CITY OF LAS VEGAS INTER-OFFICE MEMORANDUM			DATE: October 1, 2019
TO: Land Development Services Department of Building & Safety			FROM: Jennifer Shinn, P.E.  Flood Control, Engr. Associate Department of Public Works
SUBJECT:	Drainage Study for: Alexander Juliano		COPIES TO: GCW Engineers Surveyors
Cross Streets:	NEQ of Juliano Road & Alexander Road		DR Horton, Inc.
File Number:	F:\Depot\DSMemos\DS5066B.doc		Bart Anderson, P.E., DevCo
Parcel Number:	138-05-801-025, 138-05-801-027		CCRFCD
Zoning Action:	ANX-74570; ANX-74572; TMP-75979		CCPW
FEMA Flood Zone	YES	NO X	
Proposed Storm Drain	YES X	NO

**2nd RESPONSE TO COMMENTS FOR THE
TECHNICAL DRAINAGE STUDY
FOR
ALEXANDER JULIANO**

Name of Development: Alexander Juliano - Addendum #2 Date: August 2019

Re: 2nd Response to City of Las Vegas Comments on the Technical Drainage Study for Alexander Juliano (DS5066B)

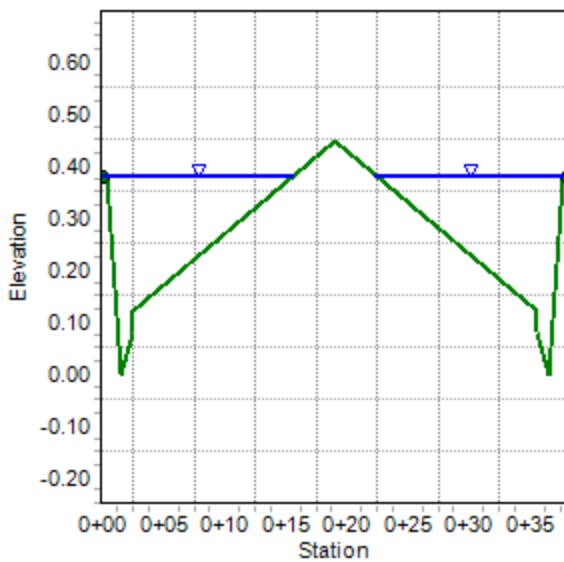
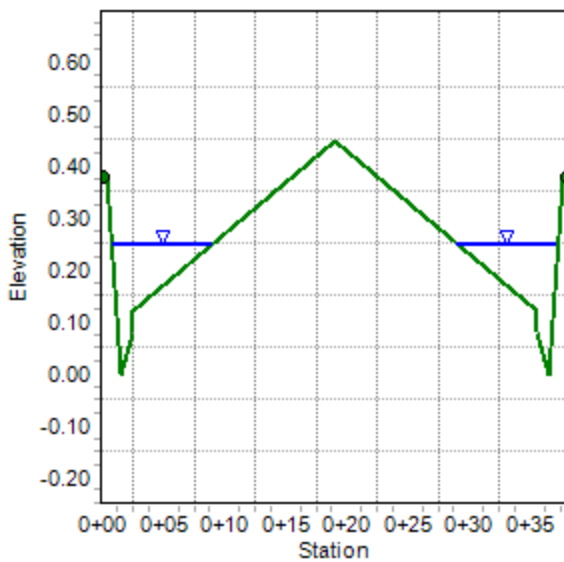
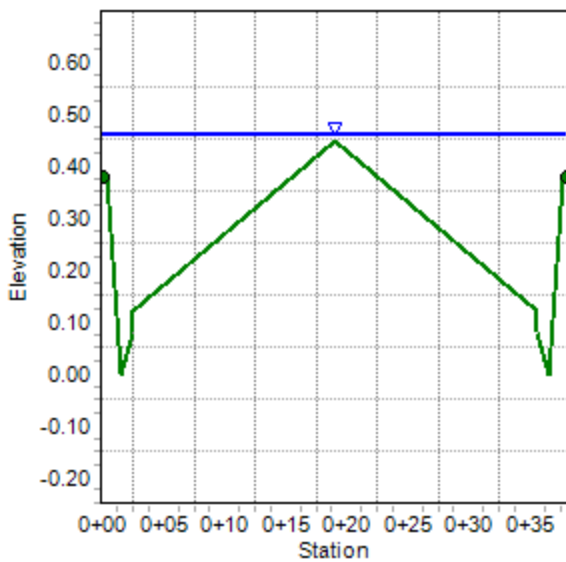
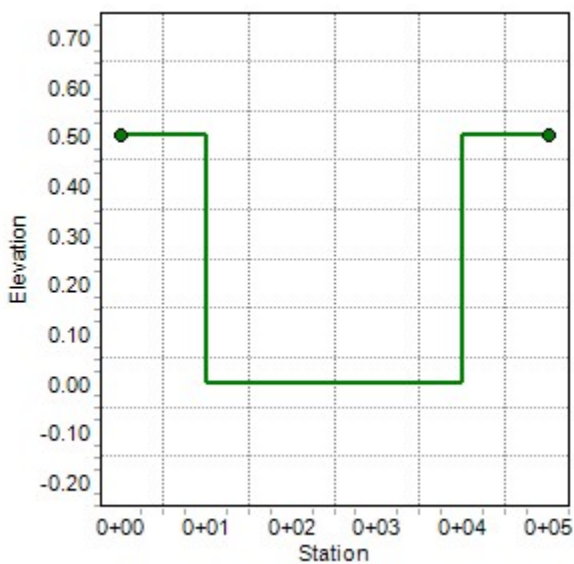
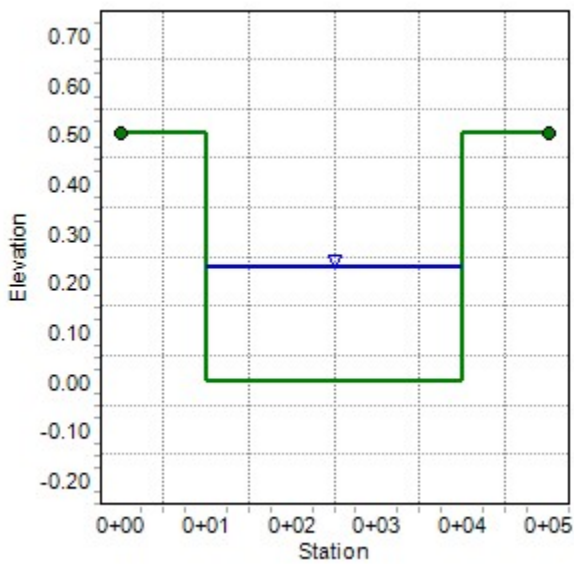
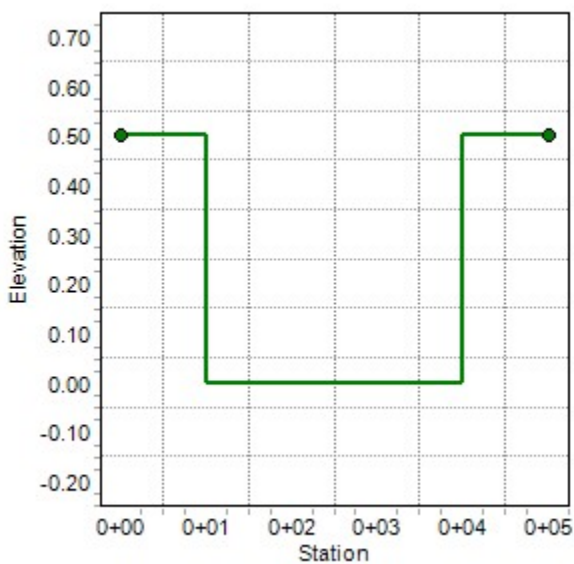
FIG 7 (Ultimate Condition Drainage Map): Hydraulic Section 6 basically is receiving flow from onsite basin DON2 with an area of 1.3 acre. However, per the "100-Year Flow Characteristics Table", Hydraulic Section 6 has a 100-year flow of 22cfs which is way out of proportion. Same situation with Hydraulic Sections 4, 5 and 7. Review and revise accordingly.

The reason that Sections 4, 5, 6, and 7 are showing higher flow rates is that the hump elevations at the entrances are not 6 inch above the water surface elevation in the street, therefore, an emergency hydraulic calculations have been performed (in addition to hydraulic calculations for actual flow rates) at those sections. The purpose is to show if the finished floors are high enough with the assumption that all street runoffs drain into the project site.

Finished floors have been checked to be 18 inches above the 100-year flow, and to be above the emergency water surface elevations. Please refer to the tables provided in Figure 7 for the 100-year and the emergency flow calculations. See Appendix D for revised and additional hydraulic computations.
